Subject: Limerick Generating Station Unit 2
Technical Specifications Change Request No. 99-05-0
Reference: Letter from B. C. Buckley (USNRC) to J. A. Hutton (PECO) dated
April 12, 2000

**TECHNICAL SPECIFICATIONS CHANGE REQUEST
NO. 99-05-0**

LIST OF AFFECTED PAGES

BASES FIGURE B 3/4.3-2

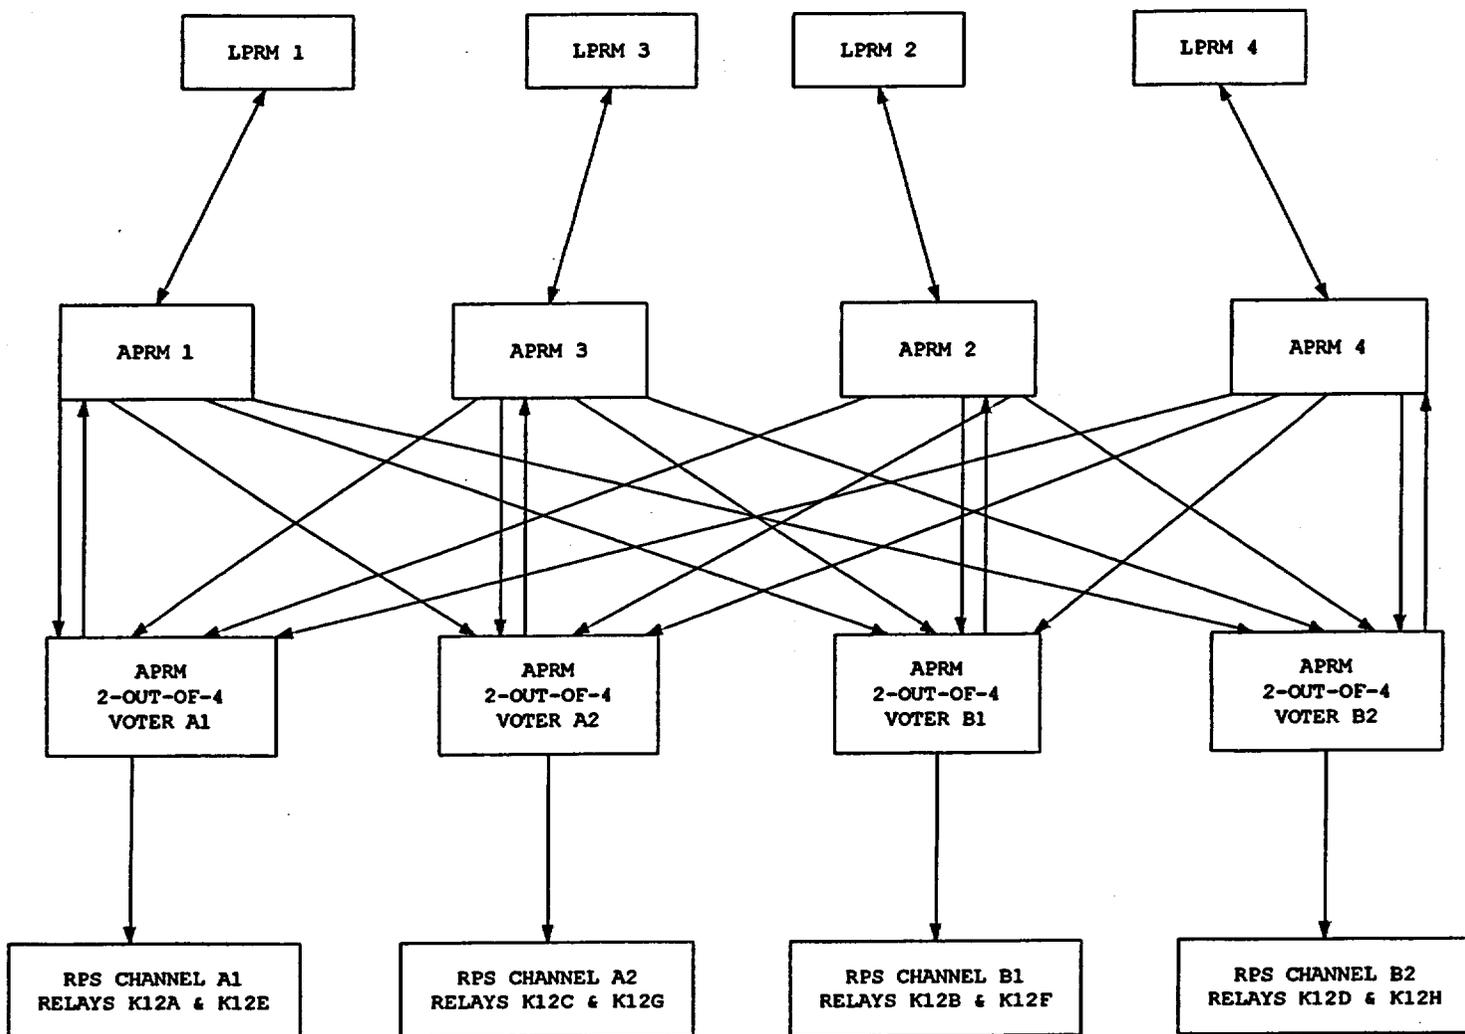
The Two-Out-Of-Four Logic Module includes 2-out-of-4 voter hardware and APRM Interface hardware. The voter Function 2.e is accomplished by the 2-out-of-4 voter hardware which includes redundant outputs. The analysis in NEDC-32410P-A took credit for this redundancy in the justification for the 12-hour allowable out of service time, so the voter Function 2.e must be declared inoperable if any of the 2-out-of-4 voter hardware's functionality is inoperable. The voter Function 2.e does not need to be declared inoperable due to any failure affecting only the APRM Interface hardware portion of the Two-Out-Of-Four Logic Module.
